Docket Item # 10
BAR CASE #2006-0034

BAR Meeting
March 15, 2006

ISSUE: Addition and alterations

LOCATION: 408 Duke Street

Figure 1 Proposed rear

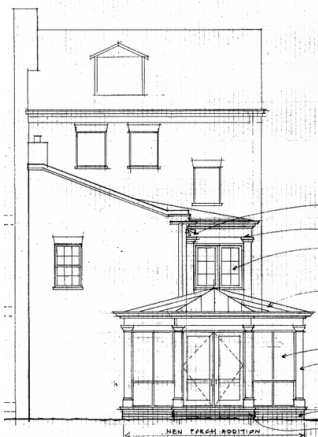
At the south end of the first level of the addition will be an octagonal wood screened porch with a standing seam copper roof. The porch will have wood columns and a pair of wood screen doors on the south end above a brick base. The second level of the addition will have a pair of wood casement windows flanked by wood pilasters

side of flounder will largely not be visible from the public right-of-way. The one story screened porch will not be visible from the public right-of-way.

Figure 2 Proposed side

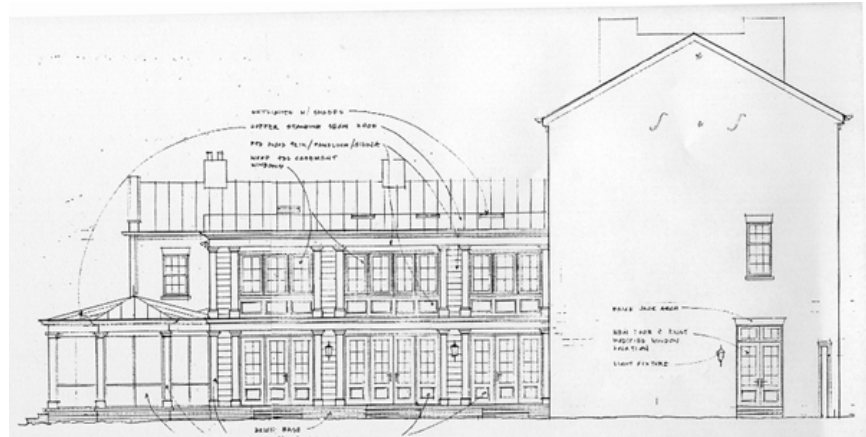
The proposed addition to the east side of the flounder is proposed to be two stories in height and approximately 36' in length and 7'6" in width. On the east side of the first level the addition will have three sets of multi-light wood doors flanked by wood multi-light sidelights on a brick base. The second level will have a similar configuration of three sets of wood casement windows above wood panels. Each of the door or window divisions will be defined by flanking wood Doric pilasters.

The proposed addition is minimally visible from Duke Street. The nearly 7' high brick wall on Duke Street to the east of the historic main block obscures views from Duke Street and the rear brick wall obscures views from nearly any area to the rear of the house. Because of the brick wall on Duke Street the only section of the new addition that will be visible is the second level. Staff also notes that the surface parking lot to the rear of the house is private property. Thus, the area to be encapsulated to permit construction of the new story two porch addition on the east

Staff also notes that there are numbers of houses in the historic district whose rear flounders have side porches. For example, the house two properties to the west at 412 Duke Street has an open side wood porch attached to the flounder section which is similar in design, materials and size to that proposed in this application.

Based upon these factors, Staff has no objection to the proposed addition to the east side of the flounder.

Figure 3 Proposed front

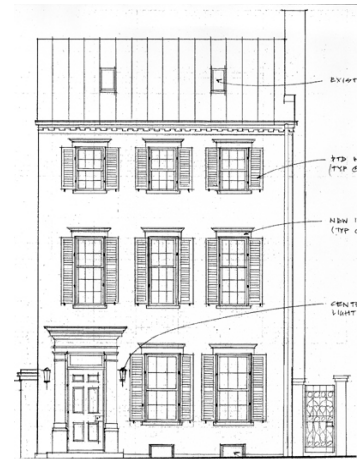
New wood lintels will be added to the existing windows on the front of the house.

A new basement window to infill an existing coal chute is proposed at the front of the house.

Staff has no objections to the proposed alterations of the first floor window to a door, the infill of the coal chute on the front of the house, the new windows lintels nor to the new skylight on the roof of the flounder section. Likewise, Staff has no objection to the pergola which is similar to a number of other pergolas that have been approved by the Board in recent years.
